UNITED STATES PATENT AND TRADEMARK OFFICE

APPLICATION NO.	FILING DATE	FIRST NAMED INVENTOR	ATTORNEY DOCKET NO.	CONFIRMATION NO.
09/930,990	08/17/2001	Wen-Shi Huang	0941-1282PUS1	8682
2292	7590	06/14/2006	EXAMINER	
BIRCH STEWART KOLASCH & BIRCH PO BOX 747 FALLS CHURCH, VA 22040-0747			PATEL, NIHIR B	
			ART UNIT	PAPER NUMBER
			3743

Office Action Summary	Application No. 09/930,990	Applicant(s) HUANG ET AL.	
	Examiner Nihir Patel	Art Unit 3743

DETAILED ACTION

FIG. 3

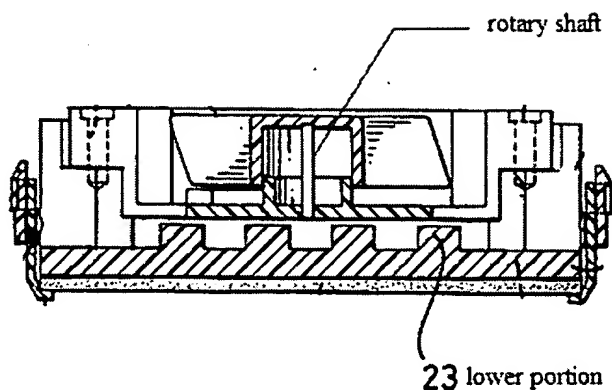
Hsieh discloses a cooling device for central processing unit that does provide a second cooling fins having a lower portion (**see figure 3 on the next page**) wherein the entire shaft is located above the lower portion of the second cooling fins and the rotary shaft is positioned away from the lower portion of the second cooling fins (**see figure 3 on the next page**). Therefore it would have been obvious to modify Budelman's invention by providing a second cooling fins having a lower portion wherein the entire rotary shaft is located above the lower portion of the second cooling fins and the rotary shaft is positioned away from the lower portion of the second cooling fins as taught by Hsieh in order to mount the fan means above the second fins.

5. As to **claims 11, 16 and 21**, Budelman teaches a heat sink with integrated blower for improved heat transfer wherein the annular cavity **416** (see **figure 4**) matches the centrifugal fan.
6. As to **claims 12, 17 and 22**, Budelman teaches a heat sink with integrated blower for improved heat transfer wherein the cooling fins are distributed around a region extending from a central region of the centrifugal fan to a periphery of the centrifugal fan but fails to teach cooling fins being distributed under a region extending from a central region of the centrifugal fan to a periphery of the centrifugal fan. Hsieh discloses a cooling device for central processing unit that does provide cooling fins being distributed under a region extending from a central region of the

centrifugal fan to a periphery of the centrifugal fan (**see figure 3 on the previous page**).

Therefore it would have been obvious to modify Budelman's invention by providing cooling fins being distributed under a region extending from a central region of the centrifugal fan to a periphery of the centrifugal fan as taught by Hsieh in order to mount the fan means above the second fins.
